SECTION 4 – SPECIALIST REPORTS

60 Dutton Street, Coolangatta

RE: Response to Information Request COM/2025/157

Response to Council Information Request – Application Number COM/2025/157 Proposed Multiple Dwelling Development – 60 Dutton Street, Coolangatta (Lot 2 on RP86756)

SERVICES LAYOUT PLAN
SCALE 1:100

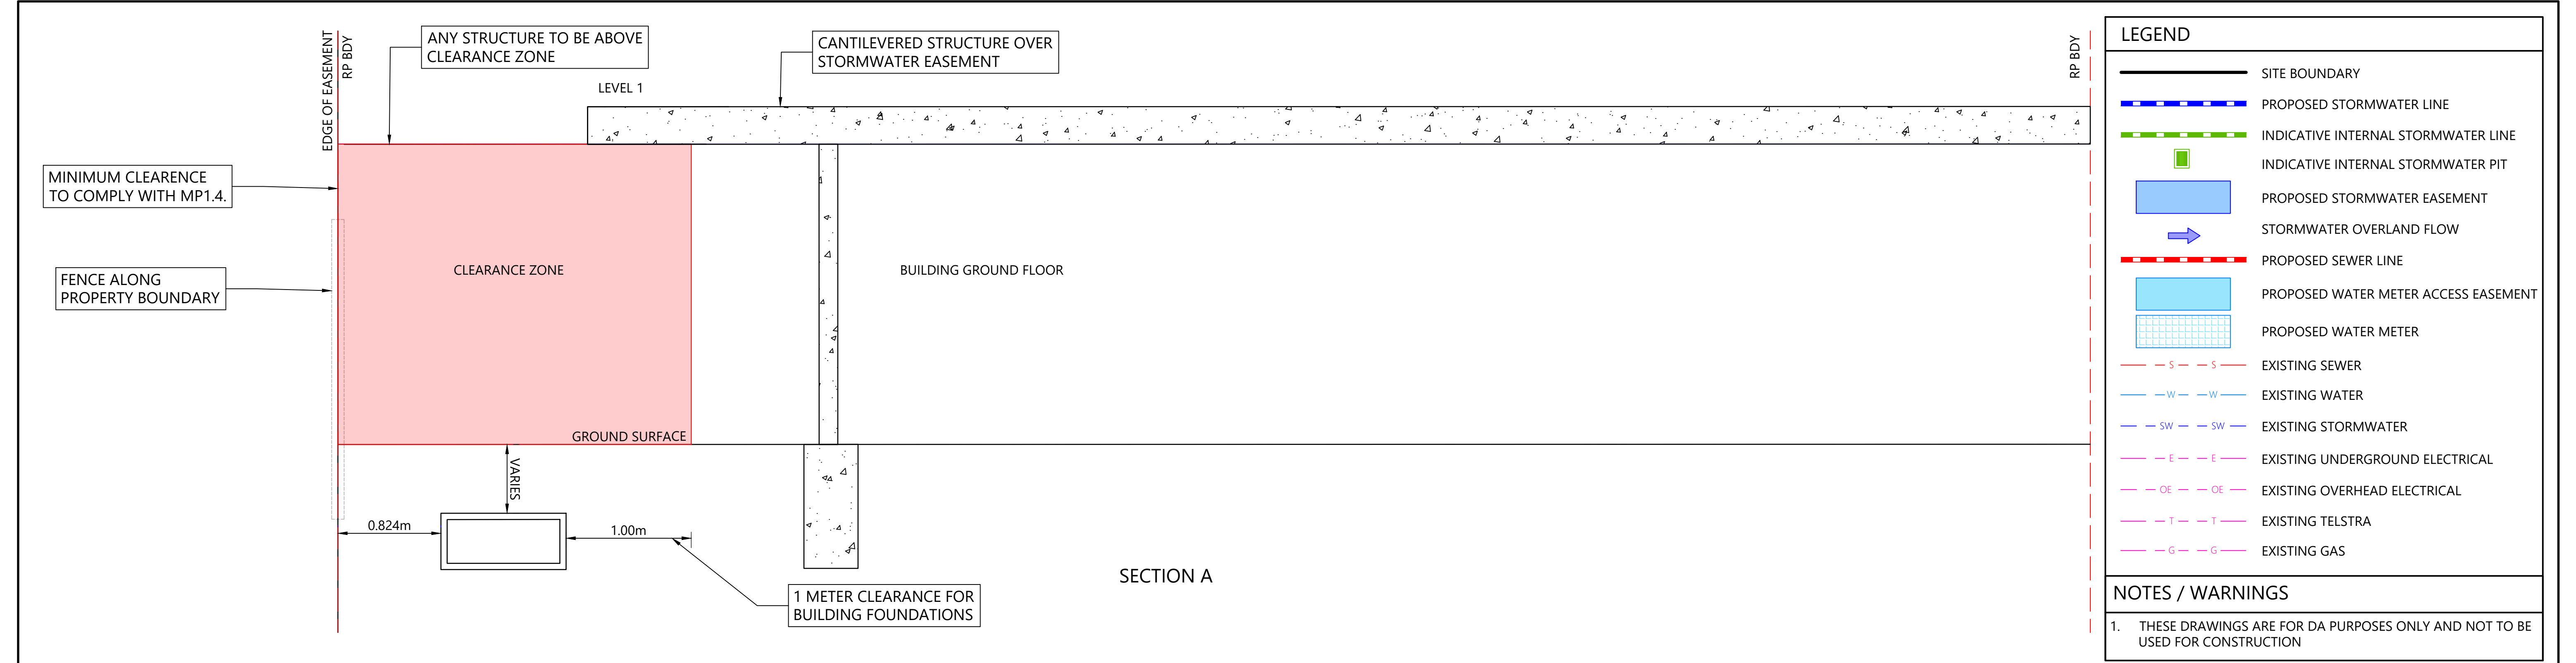
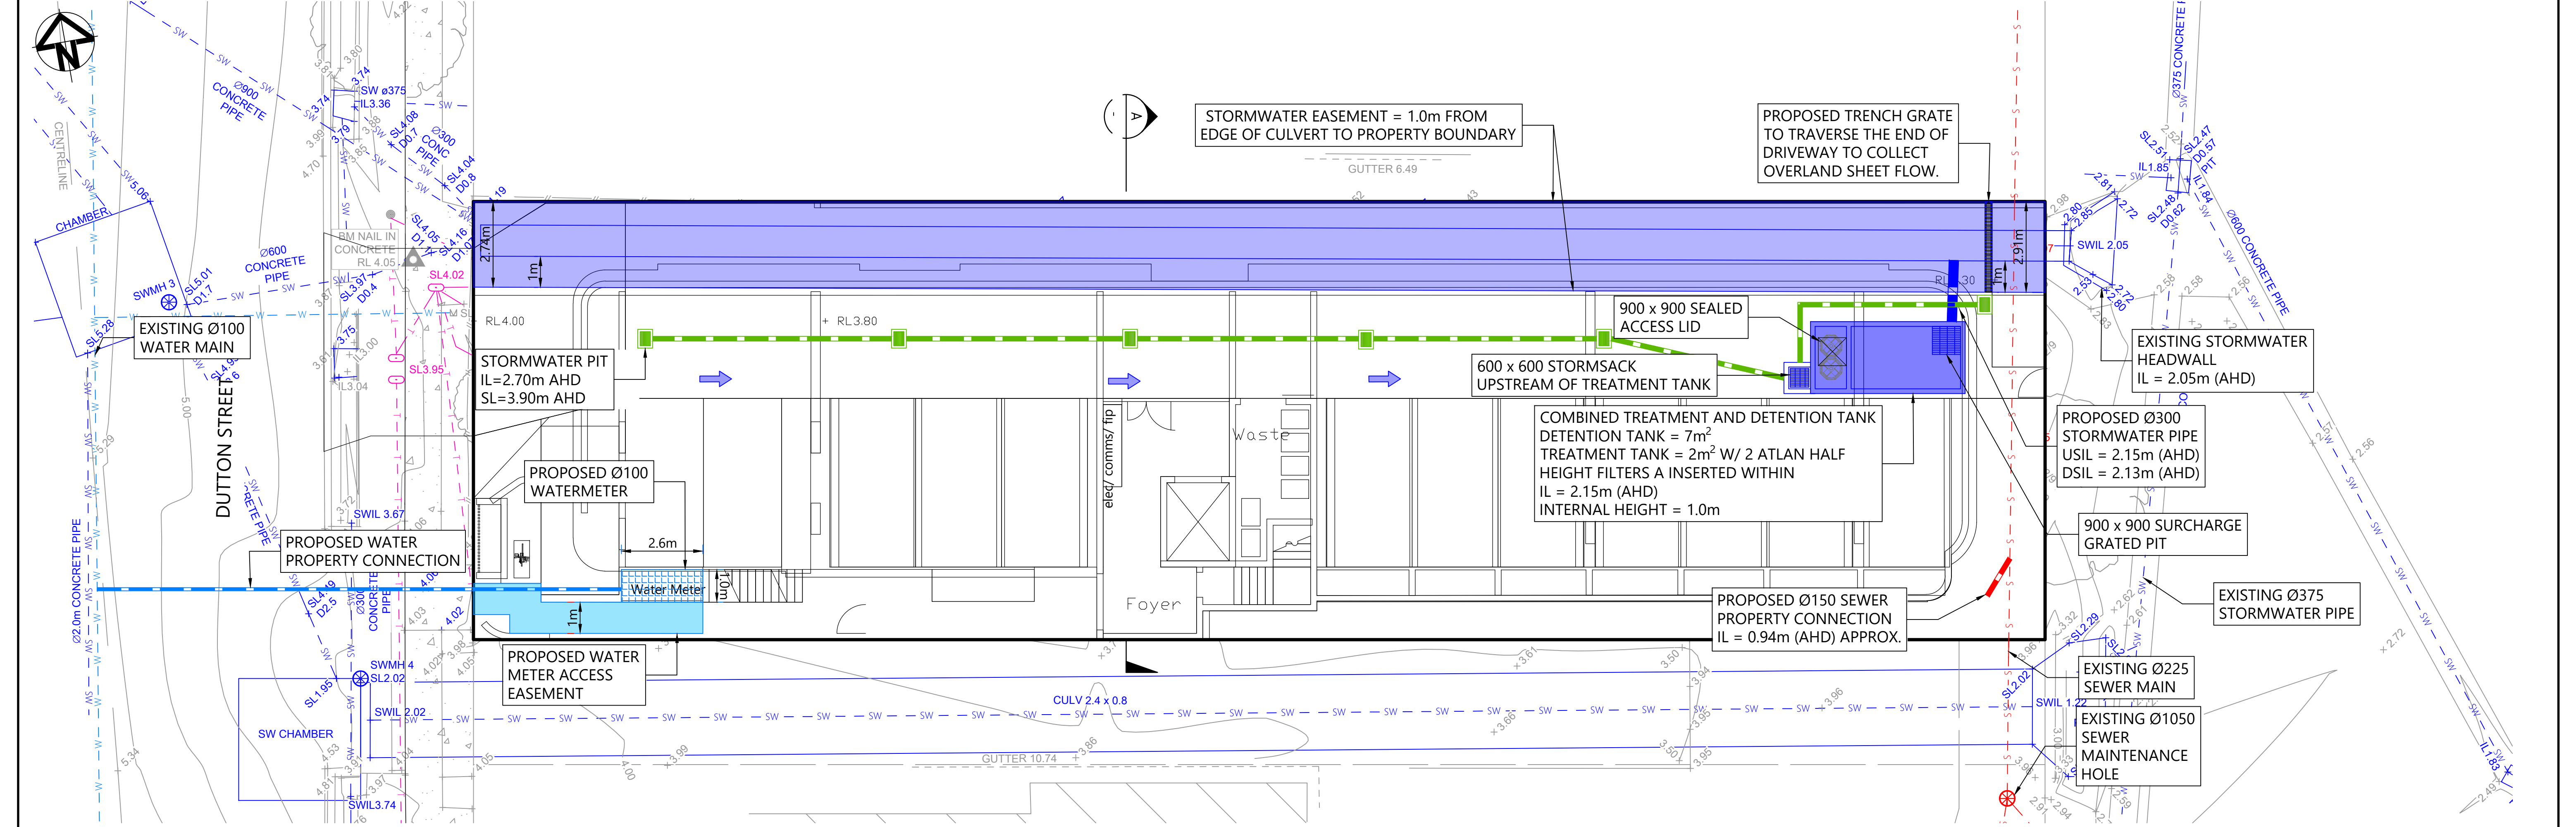
The Services Layout Plan drawing G24095-DA03, Revision 01 shows an assumed stormwater/drainage easement over the existing 1200 X 900 RCBC within the property. No stormwater/drainage easement exists according to Council property records. As such, the Applicant is requested to amend the drawing, nominating a stormwater/drainage easement in favour of Council in accordance with QUDM (2017) Section 3.12.4 Drainage easement dimensions in compliance with PO10 above.

The applicant may remove the "Assumed Stormwater Easement" and replace with "Proposed Stormwater Easement" amending the plan in accordance with the above.

It is unclear how surface stormwater from Catchment 4 (Driveway) are conveyed to the treatment tank. No plan supports the claim that surface stormwaters are conveyed to the treatment tank for final treatment by the Atlan filters. As such, the applicant is to provide a plan of the proposed internal stormwater network for Catchment 4 in connection to the treatment tank reflecting the submitted MUSIC model OR amend the MUSIC model with the Catchment 4-Driveways entirely bypass updating any results in compliance with PO3 above. The plans are required to clearly demonstrate a volumetric easement that is 1m wide from the finished floor level below the sewer to the soffit of the floor above as per section 3.3 of the Gravity Sewer Infrastructure In Basements Guideline.

The applicant may provide an Atlan FlowGuard at the end and across the driveway treating stormwater before discharge to the lawful point of discharge amending the MUSIC model accordingly updating any results in accordance with the above

It is unclear how surface stormwater from Catchment 4 (Driveway) is conveyed to the detention tank. No plan supports the claim that surface stormwaters are conveyed to the detention tank. As such, the applicant is to provide an amended Services Layout Plan drawing #G24095-DA03, Revision 01 of the proposed internal stormwater clearly demonstrating Catchment 4 in connection to the detention tank reflecting the submitted DRAINS model OR amend the DRAINS model with the Catchment 4-Driveway as entirely bypass updating any results in compliance with PO5 above.

The Applicant may provide a trench grate at the end and across the driveway diverting stormwater to the detention tank before discharge to the lawful point of discharge, amending the DRAINS model accordingly and updating any results in accordance with the above.

Council will not accept the proposed lawful point of discharge. The proposed lawful point of discharge is within Goodwin Park which is State controlled land. Stormwater discharge to State controlled land cannot be permitted unless consent is granted by the State authority. As such, the applicant is required to amend the Services Layout Plan drawing #G24095-DA03, Revision 01 demonstrating a lawful point of discharge in accordance with City Plan Policy SC6.11 Land development guidelines 4.4.5 (Downstream drainage requirements).

The Services Layout Plan (Dwg Ref: DA03-G24095-02) has been amended and the word "assumed" replaced with "proposed".

The Services Layout Plan (Dwg Ref: DA03-G24095-02) has been amended to include indicative internal stormwater infrastructure. Due to the sites existing topography, the stormwater runoff generated by the driveway will overland sheet flow towards the eastern boundary and will be collected via a grated trench inlet pit and conveyed towards the sites underground combined stormwater detention and treatment tank.

The Services Layout Plan (Dwg Ref: DA03-G24095-02) has been amended to include indicative internal stormwater infrastructure. Due to the sites existing topography, the stormwater runoff generated by the driveway will overland sheet flow towards the eastern boundary and will be collected via a grated trench inlet pit and conveyed towards the sites underground combined stormwater detention and treatment tank.

The Services Layout Plan (Dwg Ref: DA03-G24095-02) has been amended to provide an LPOD in accordance with the SC6.11 Land development guidelines 4.4.5 (Downstream drainage requirements).

Attachment A Updated plans of development

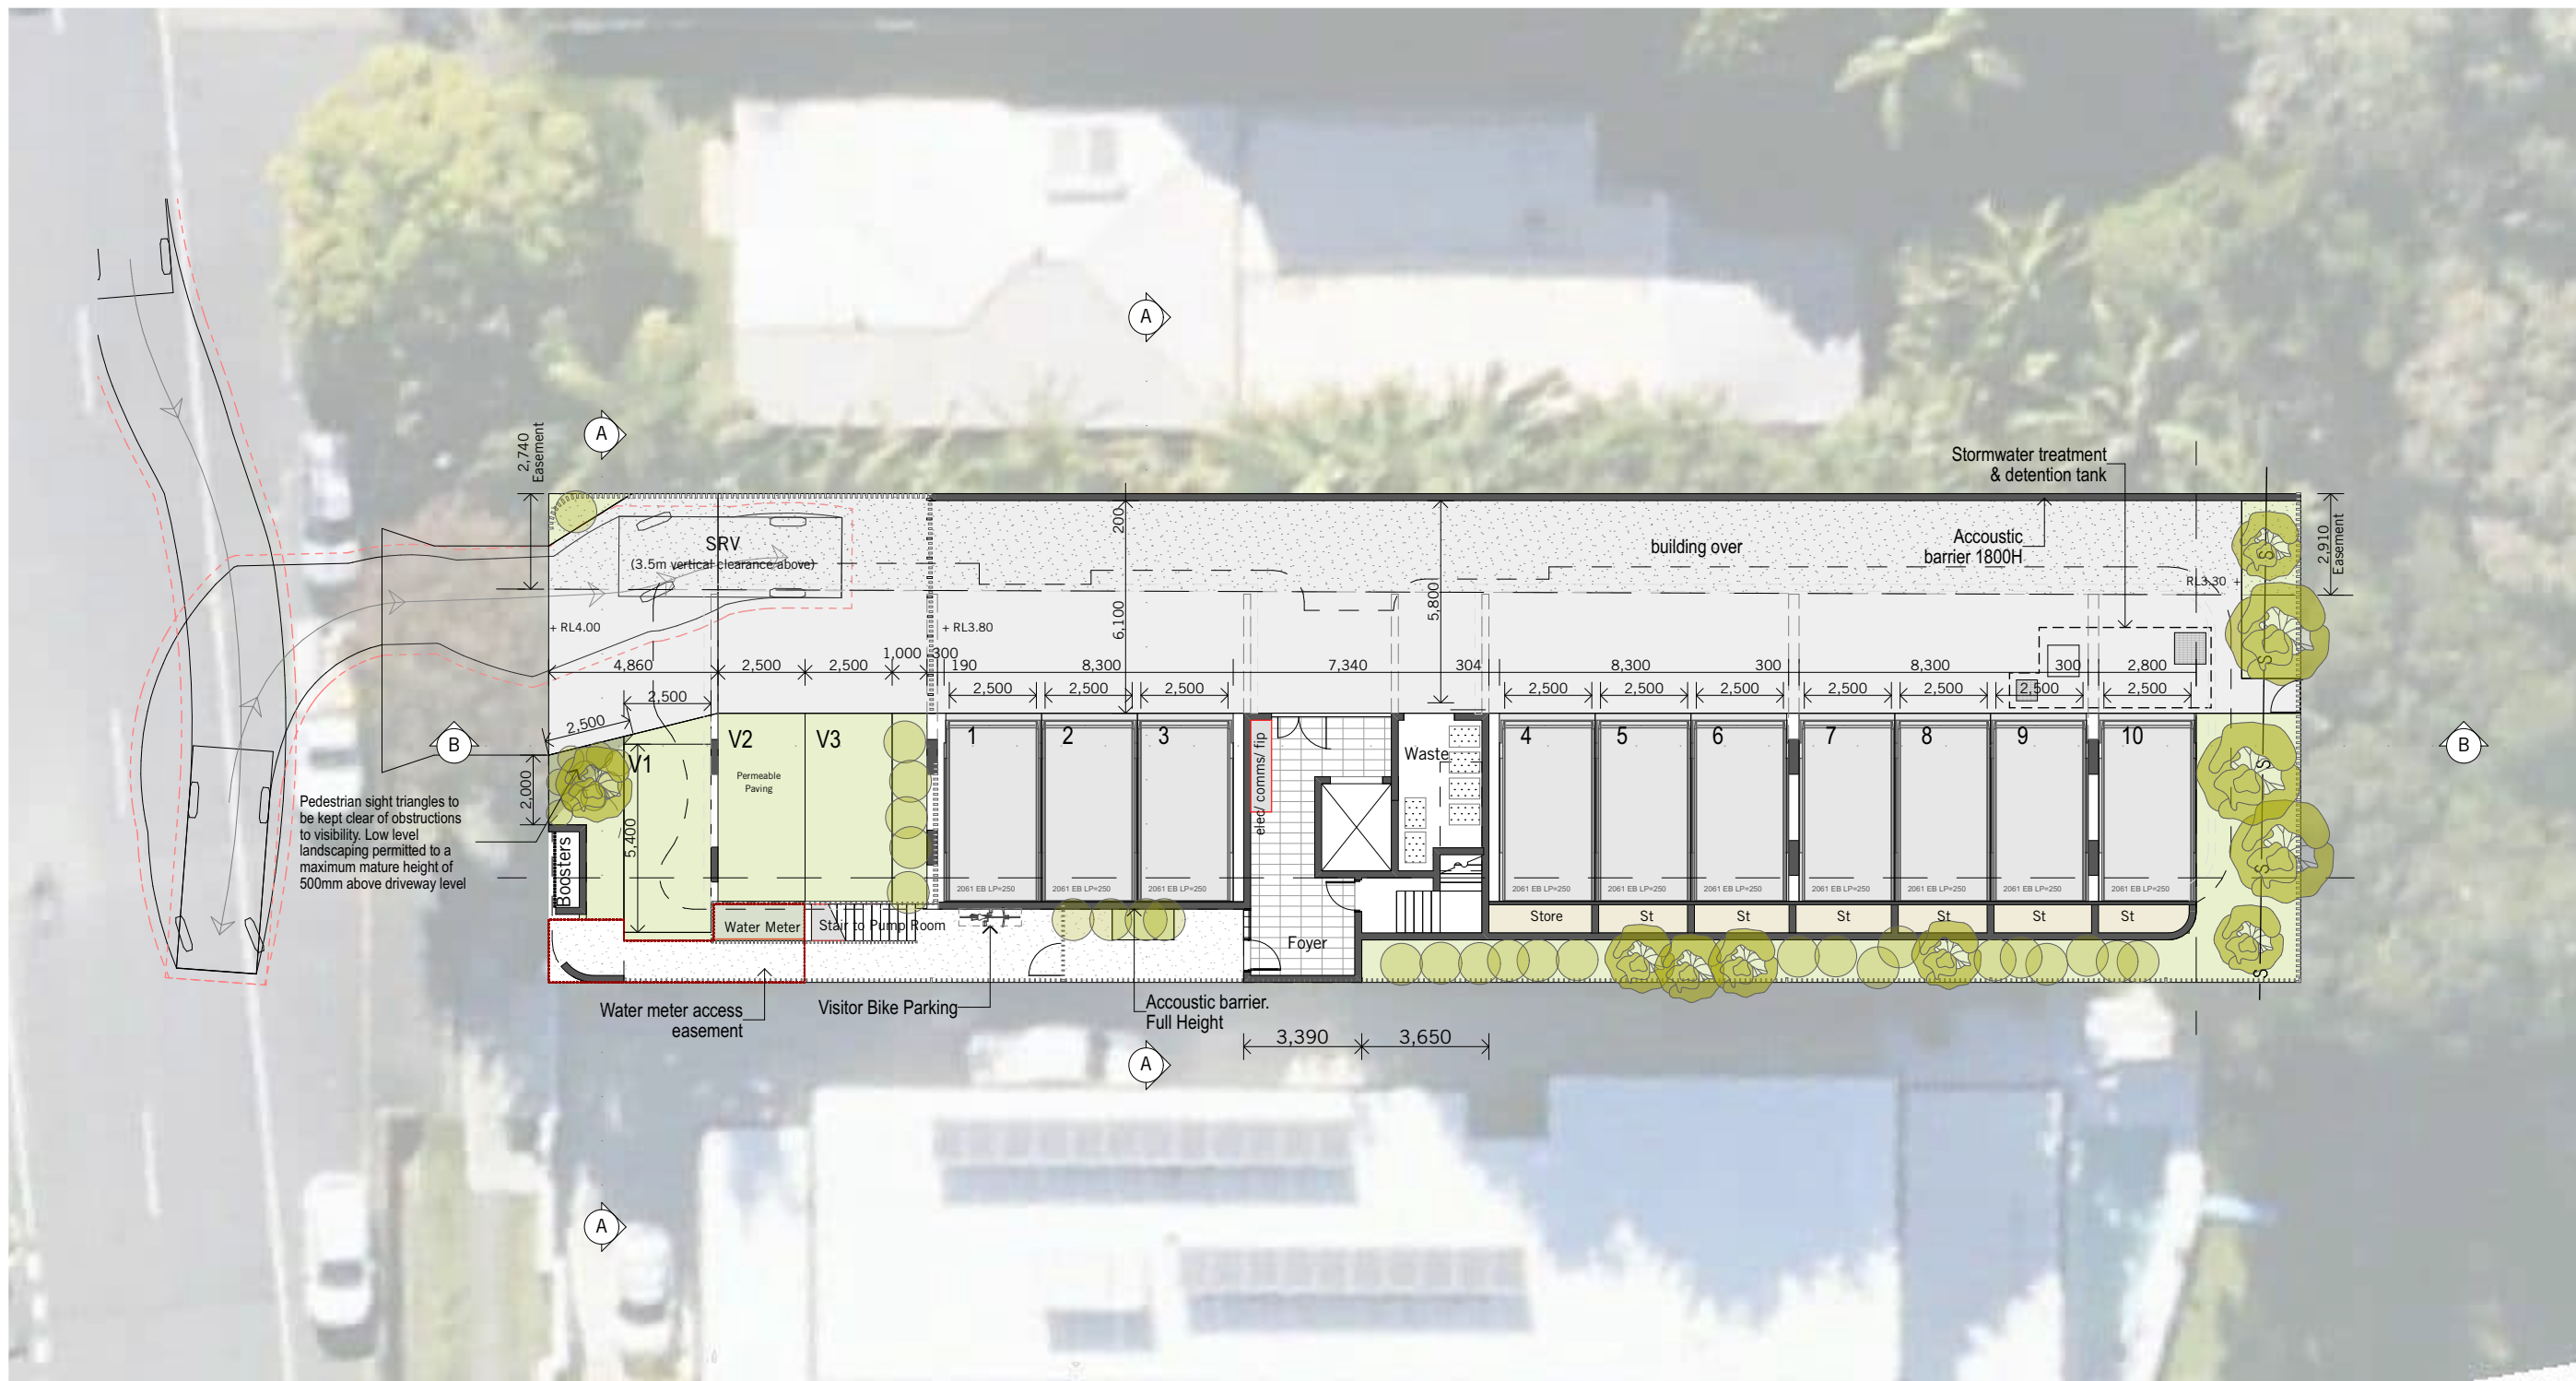
Performance outcome PO4 of the '*Solid Waste Management Code*' requires that waste and recycling servicing points are appropriately located and designed to facilitate safe, unobstructed and efficient servicing of waste containers by providing amended plans detailing all relevant dimensions.

Assessment of the submitted information / plans has identified that provision of wheelie bins shall not be a safer outcome given the height of the proposed development. The development must therefore be serviced by a bulk bin service for general and recyclable waste.

Additional information is requested to be submitted, detailing the location of all proposed bulk bin storage and servicing points. The design and construction of all points must comply with sections 13 and 14 of the '*City Plan Policy – Solid Waste Management*'.

Response to Item 15.
